TfNSW reference: REN25/00089/002

**SSD-77527735, Mangoplah Battery Energy Storage System, 4178 Holbrook Road, Mangoplah NSW 2652;
Response to Environmental Impact Statement**

SSD-77527735, Mangoplah Battery Energy Storage System, 4178 Holbrook Road, Mangoplah NSW 2652; Response to Environmental Impact Statement

Figure 1: Vehicle outline beyond paved road area (indicated with yellow highlight) at Rest Area 5. Source: Figure RA5 of OSOM Vehicle Route Assessment.

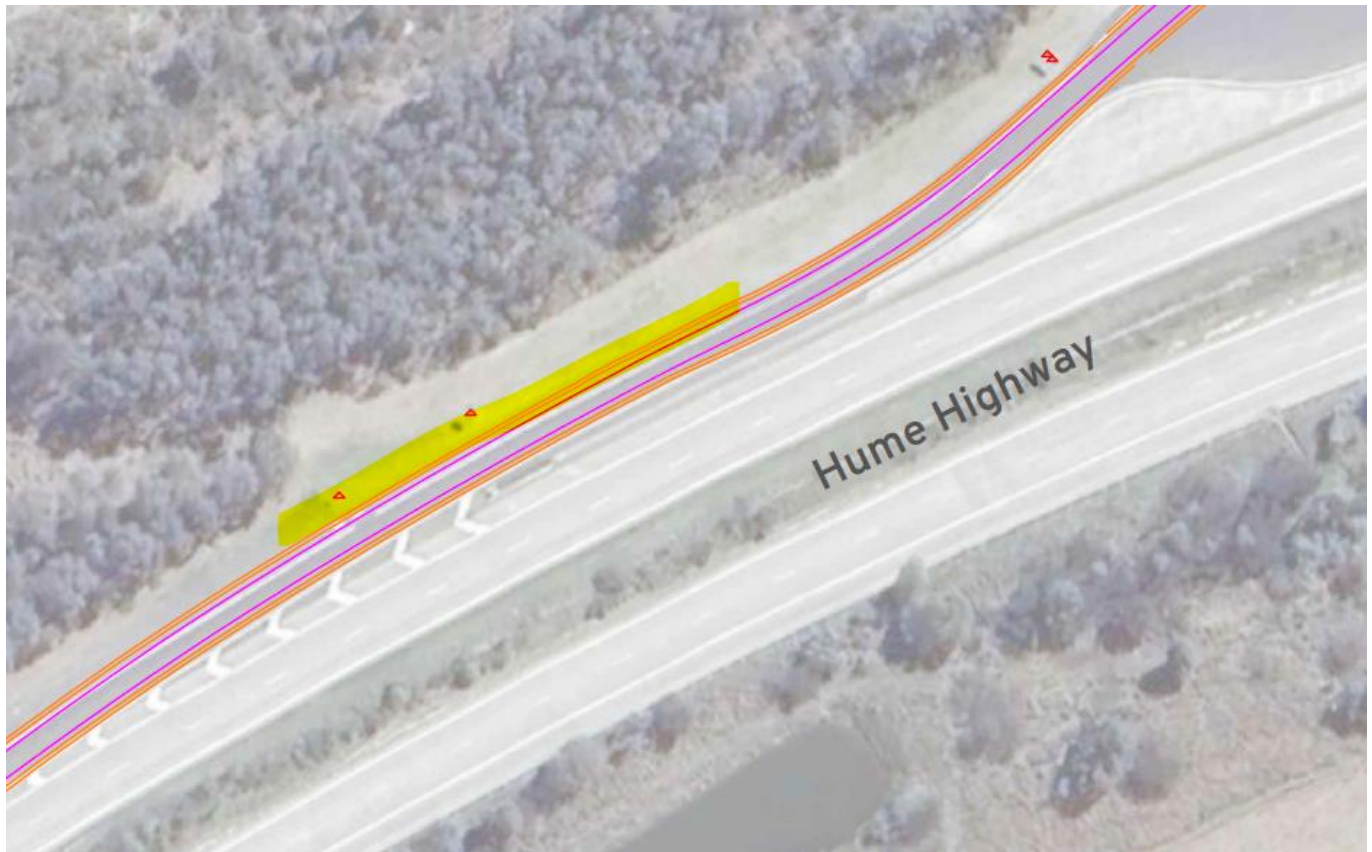
- c. The swept paths provided indicate that the OSOM traverses outside of the marked pavement at Rest Area 5 on the Hume Highway, see Figure 1. Swept paths are to be updated to demonstrate that OSOM movements can occur within the marked roadway, or strategic concept designs are to be provided with road and/or shoulder widening pavement designs. [Strategic-Design-requirements-for-DA-Factsheet.pdf](#)
